**Town of Nags Head Planning Board
Nags Head Municipal Complex Board Room
Tuesday, September 17th, 2024; 9:00 a.m.**

MEMORANDUM

Subject: Special Use Permit/Site Plan Review, 425 W. Health Center Drive

Purpose/Request: Construction of an approximately 3,460 square feet, two story, eight-bedroom dormitory (duplex) and all associated site improvements. This dormitory is for use by Town of Nags Head workforce or as approved by the Town Manager.

SITE, UTILITY & LANDSCAPING PLAN

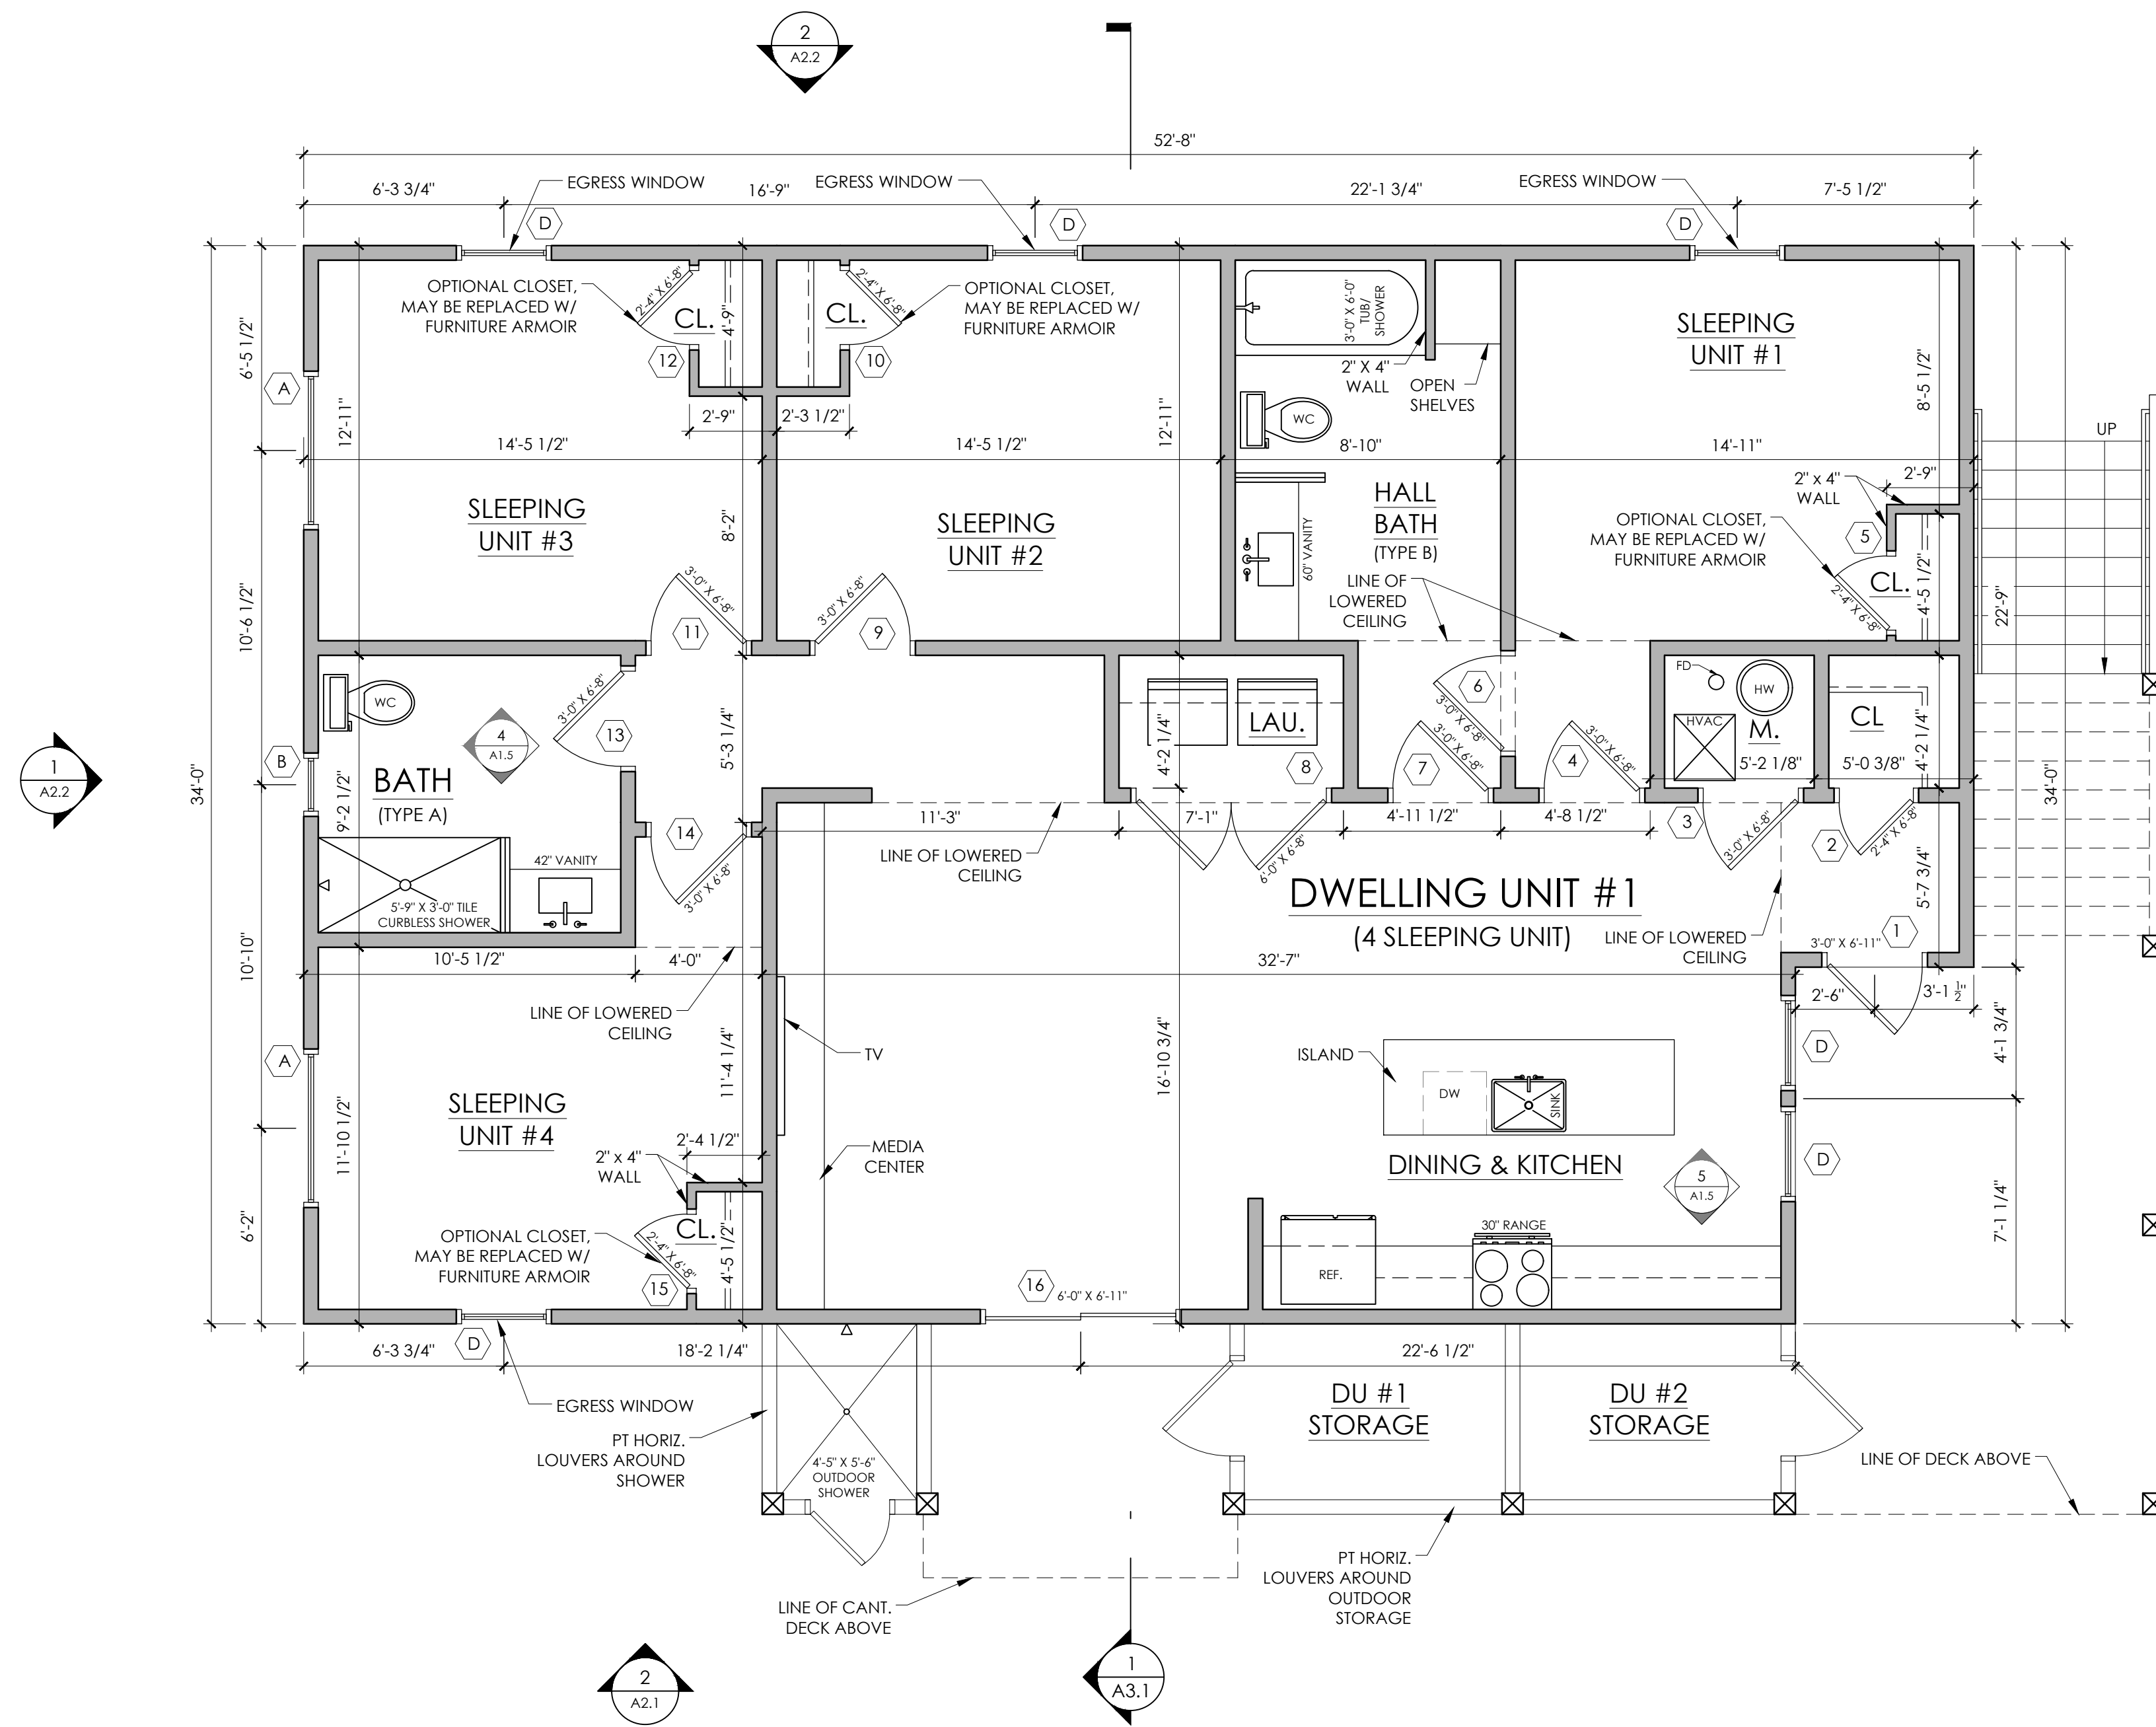
The proposed redevelopment of the dormitory, including the removal of the non-functional helipad and various other improvements, conceptually shows a lot coverage of 29.03%, slightly above the allowable 28.6%. However, we are awaiting an opinion from our town attorney regarding the correct boundary of the property. It is likely that once the property boundaries are confirmed, the total lot area will increase, which would reduce the lot coverage percentage to 28.6% or less. Please note the discrepancy between the property boundaries shown in Dare County records versus those on the survey (attached). This conflict will be resolved before the Board of Commissioners reviews the project, and the property will not be deemed compliant until the lot coverage is confirmed to be 28.6% or less of the total lot area

- Parking: Pursuant to Article 10, Table 10-2, *Required Parking by Use*, dormitory uses are required to provide one parking space for every four occupants. For this structure, which will have a maximum occupancy of 16, a total of four (4) parking spaces are required. However, considering that this structure is intended to house the Town of Nags Head workforce, including seasonal lifeguards, it is

Currently, there are 37 existing parking spaces onsite. Based on a liberal application of the medical office parking standard to the Community Care Clinic, which is also located onsite, we estimate that approximately 25 parking spaces are necessary for the clinic. This leaves 12 parking spaces available for dormitory use, providing parking for three-quarters of the dormitory occupants. Ideally, 16 spaces—one per occupant—would be available for this use.

Based upon staff's review of the proposal, we recommend approval of the Special Use Permit/Site Plan Review as submitted conditioned upon the proposed lot coverage not exceeding 28.6%.

DRAWING NAME:
**EXTERIOR
ELEVATIONS**

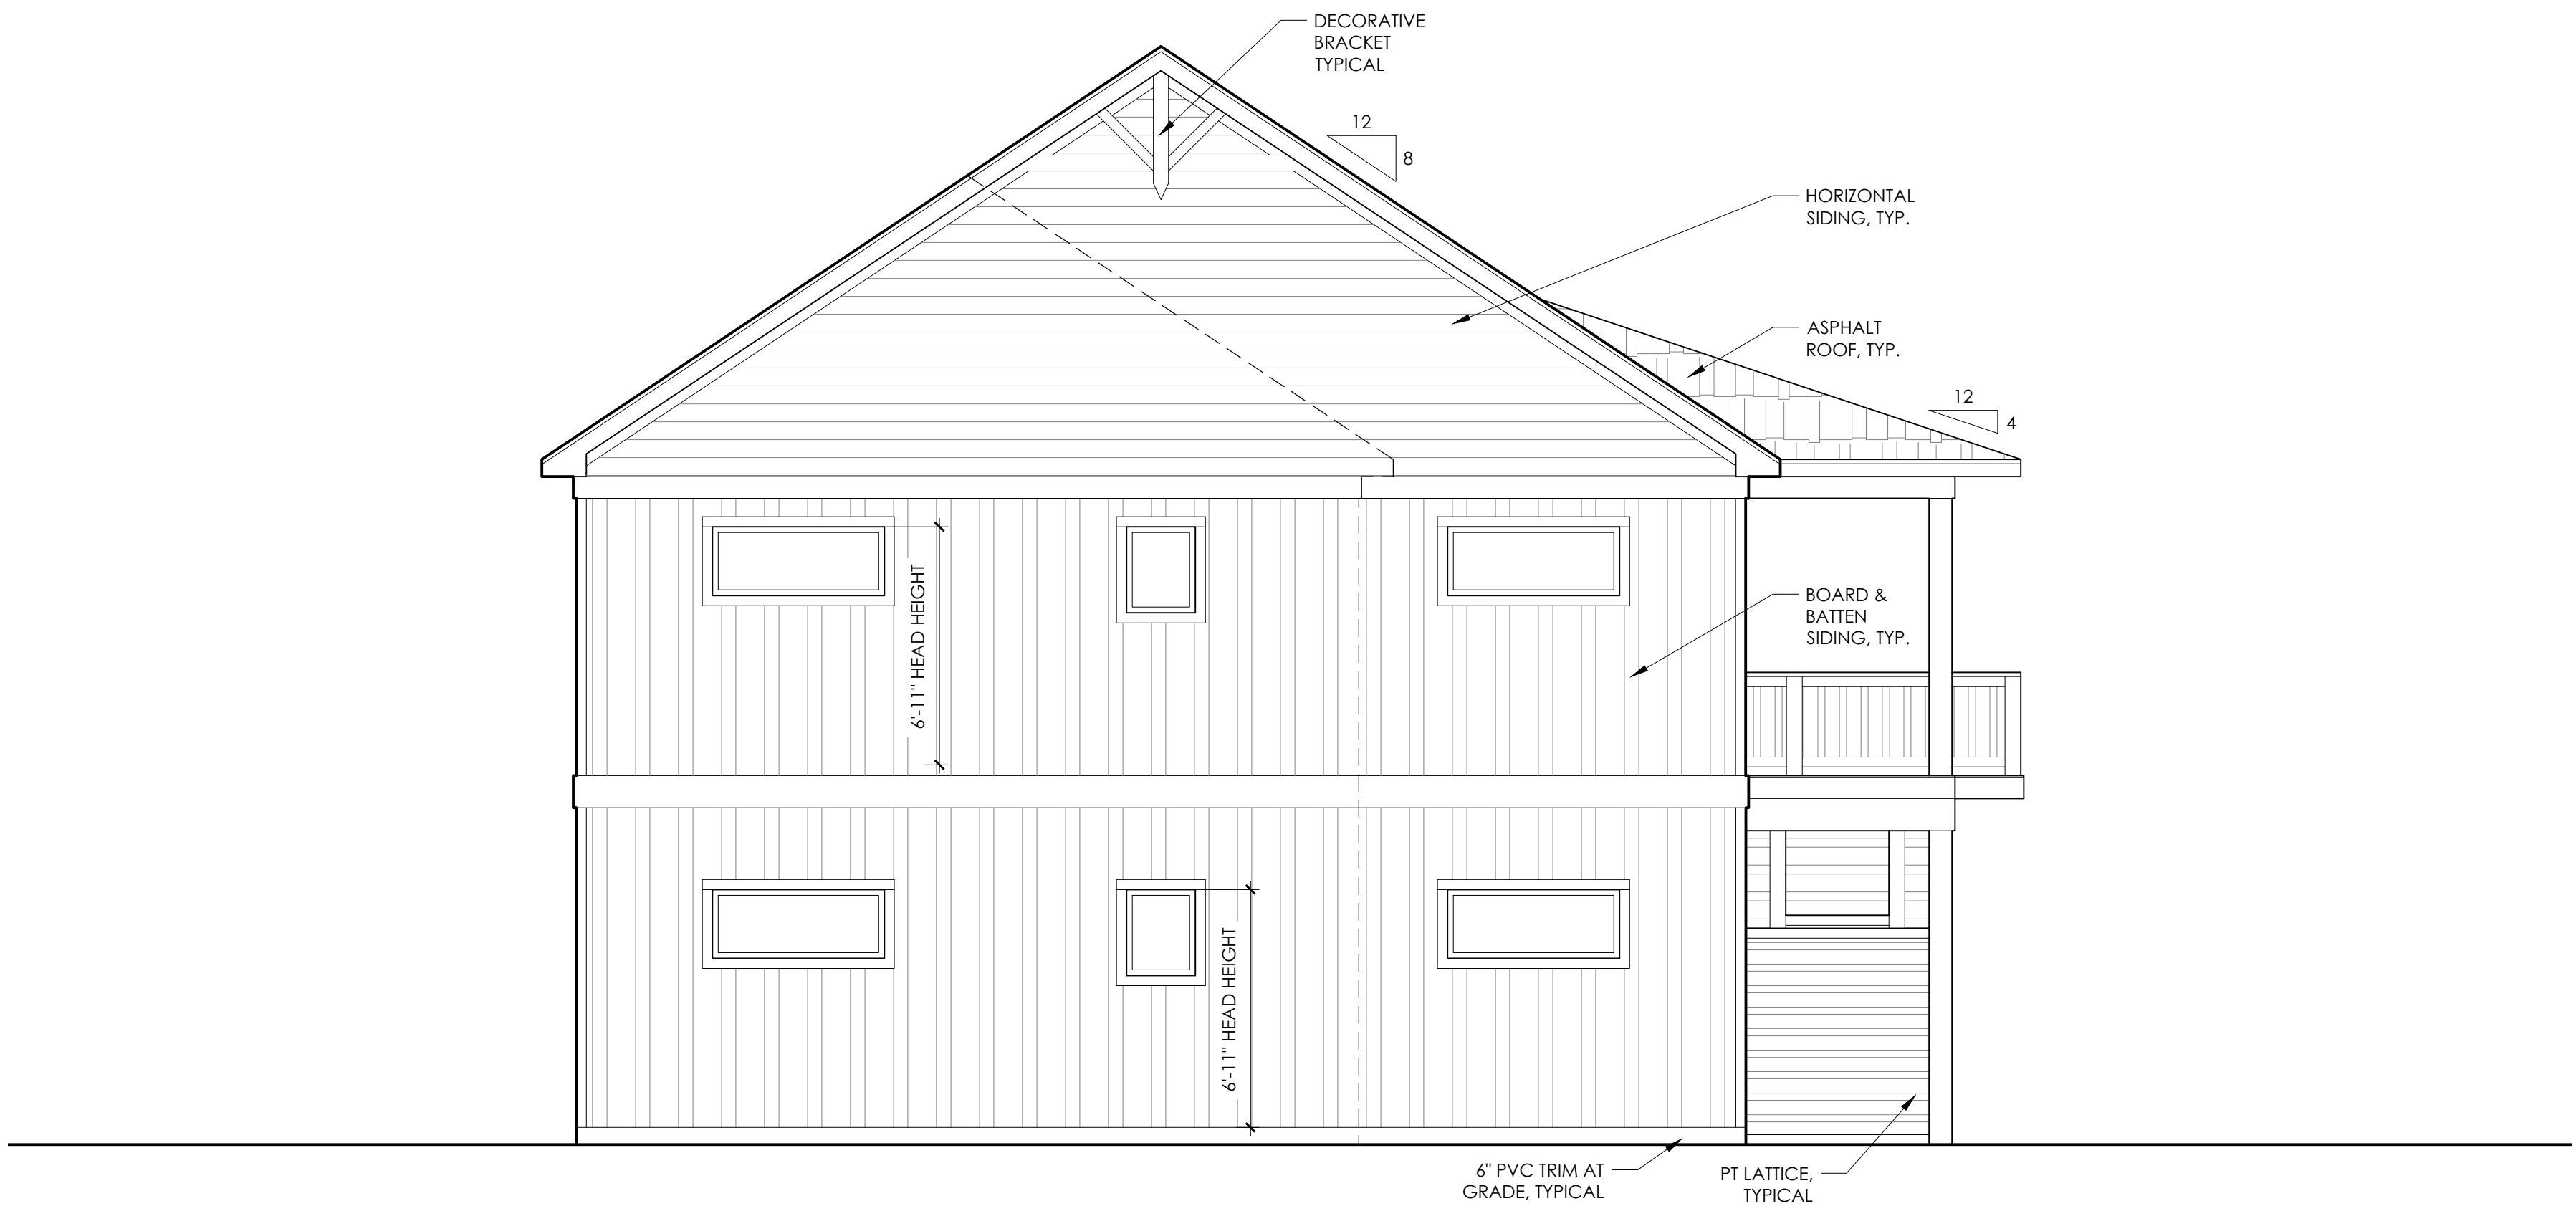
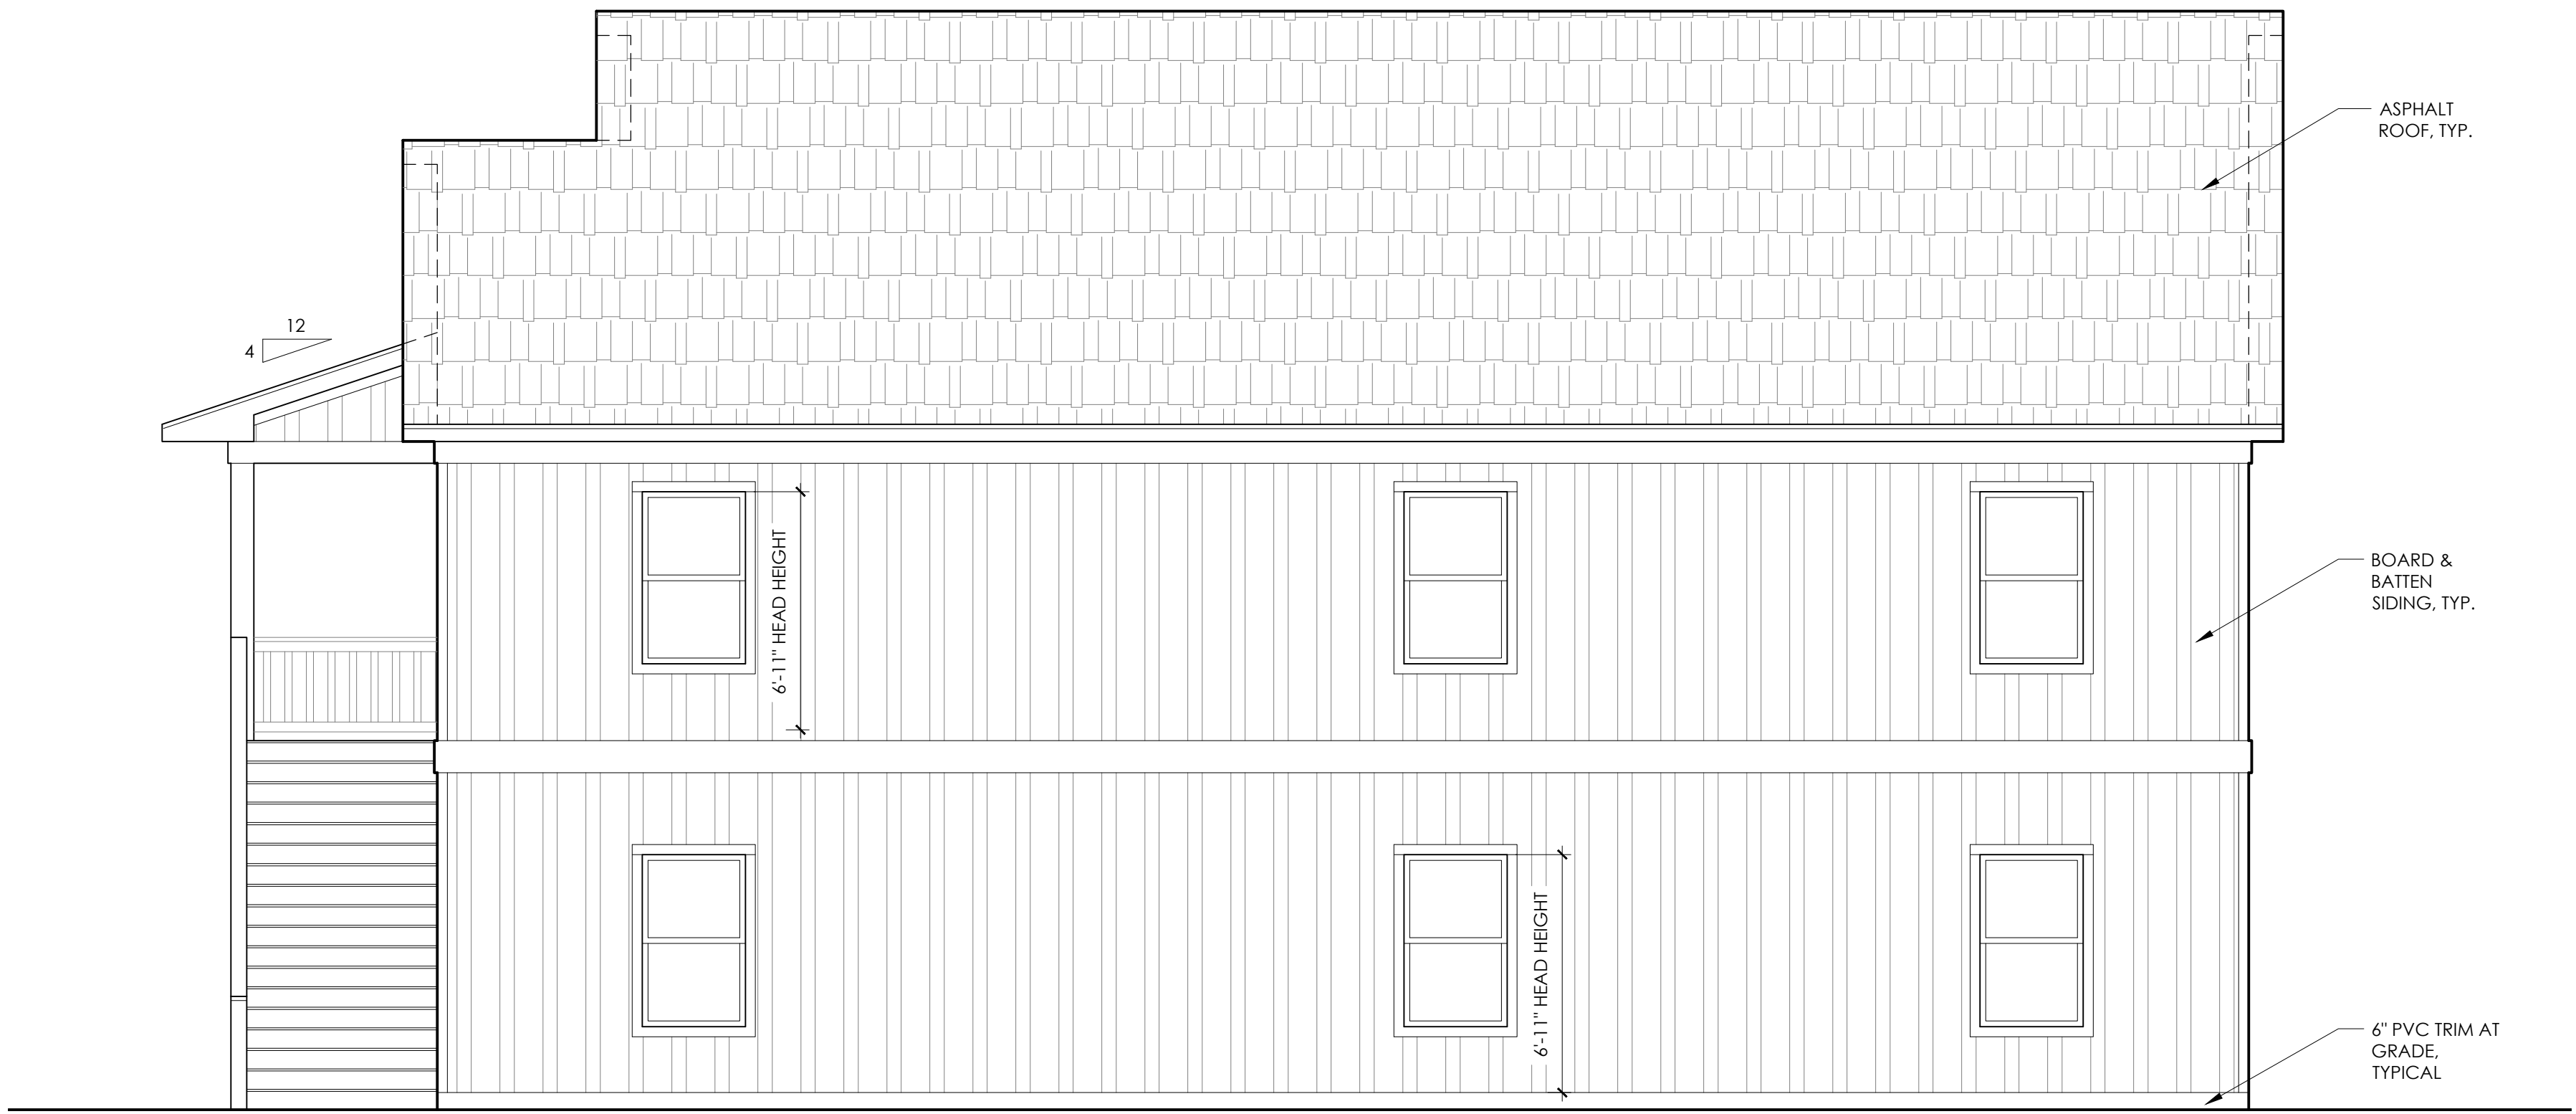
- Height: The maximum allowable building height within the Town is 35 feet; however, pursuant to Section 8.2.1, Dimensional requirements, total height may be increased to 42 feet with the use of an 8:12 roof pitch or greater. The applicant has proposed a structure with an overall height of approximately 32 feet measured from grade, while also proposing an 8:12 roof pitch therefore height is compliant.

- Architecture Design Standards: Section 10.82 of the UDO, Applicability, states that Commercial Design Standards shall apply to all building construction or remodeling projects requiring a special use permit or site plan review. This project must adhere to the Commercial Design Standards set forth within Part VI of the UDO. As proposed this project will comply with standards set forth in Division II – Building Design including a human scale design with a second-floor covered porch, residential style single or double hung windows, board and batten siding, gable brackets, etc. We have requested that the architect incorporate a few other elements such as workable shutters and column trim.
